CITY PLAN COMMISSION**THURSDAY, NOVEMBER 7, 2024****FILE NUMBER:** S245-011**SENIOR PLANNER:** Hema Sharma**LOCATION:** Mockingbird Lane, west of Harry Hines Boulevard**DATE FILED:** October 10, 2024**ZONING:** PD 1065**PD LINK:** <https://dallascityhall.com/departments/city-attorney/Articles/PDF/Article%201065.pdf>**CITY COUNCIL DISTRICT:** 2**SIZE OF REQUEST:** 32.2926-acres**APPLICANT/OWNER:** Chris Schultz; DA12, LLC

REQUEST: An application to create a 32.2926-acre lot from a tract of land in City Block 7924, 7925, 1/7926, and A/7926 on property located on Mockingbird Lane, west of Harry Hines Boulevard.

STAFF RECOMMENDATION: The request complies with the requirements of the PD 1065; therefore, staff recommends approval of the request subject to compliance with the following conditions:

PROJECT:
 PRELIMINARY PLAN
 EMB ADDITION
 LOT 1, BLOCK B/7926
 OF A PORTION OF
 RIVER BEND ON STEWARTS
 PARKWAY
 HINTON INDUSTRIAL TRACT
 TRACT 1, BLOCK A/7928
 THOMAS MANNIN SUBDIVISION, NO. 958
 CITY OF DALLAS, DALLAS COUNTY, TEXAS
 CITY PLAN FILE NO. 5845-011
 ENGINEERING NO. DP-1000000000

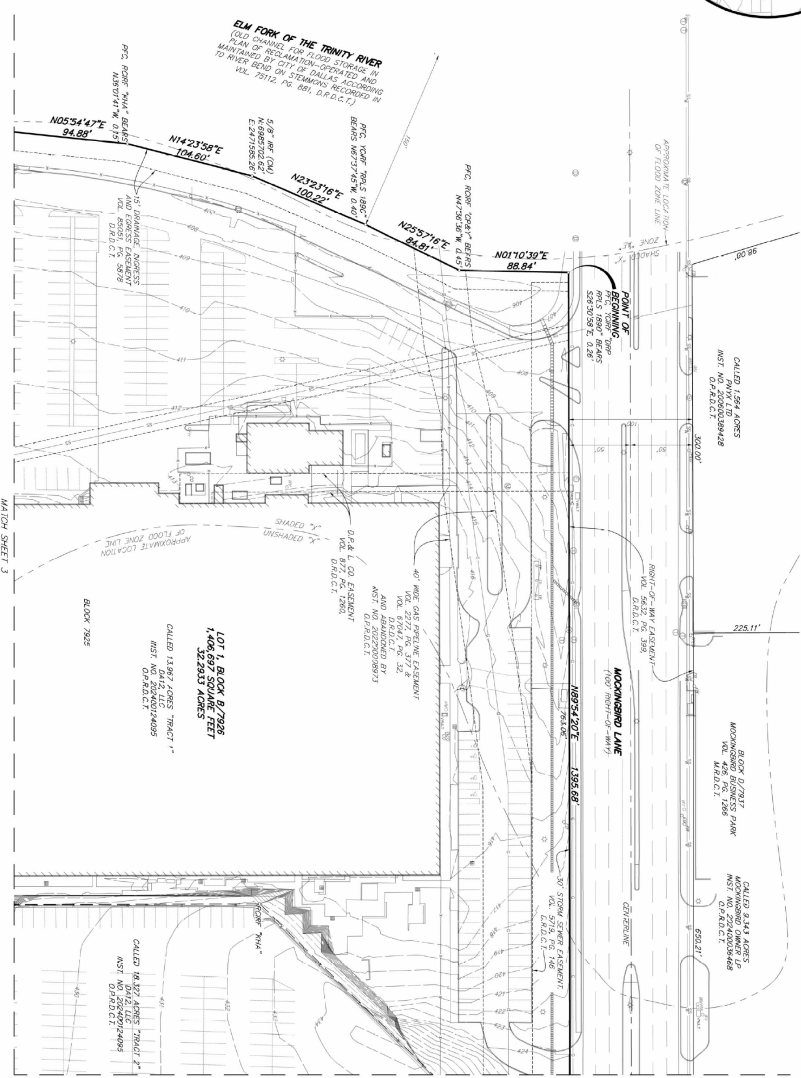
16. Provide a turn-around per the City of Dallas Standards at the end of Hinton Street. *Section 51A-8.506(b)*

17. Provide a turn-around per the City of Dallas Standards at the end of Plantation Road. *Section 51A-8.506(b)*
18. Must coordinate with Transportation Department for any traffic signal requirements that are deemed necessary for improving pedestrian accessibility and safety related to site development (Contact Srinivasa Veeramallu with Traffic Signals). *51A-8.606, 51A-8.608*

19. On the final plat, determine the 100-year water surface elevation across this addition.
20. On the final plat, dedicate floodway easement, floodway management area or floodway easement (within common area), with the appropriate easement statement included on the face of the Plat. *51A 8.611(d); DWU Floodplain Management; Drainage Design Manual Addendum V*

22. On the final plat, specify minimum fill and minimum finished floor elevations. *Section 51A-8.611(d), Trinity Watershed Management.*
23. On the final plat, show the natural channel set back from the crest of the natural channel. *Section 51A-8.611(d), Trinity Watershed Management.*

34. Prior to final plat, compliance with City's street lighting standards including illumination standards, material, installation, and activation per Street Design Manual.
35. Prior to the final plat, remove the fence encroachment in Hinton Street right-of-way and provide written confirmation and pictures.
36. On the final plat, identify the property as Lot 2 in City Block A/7925.
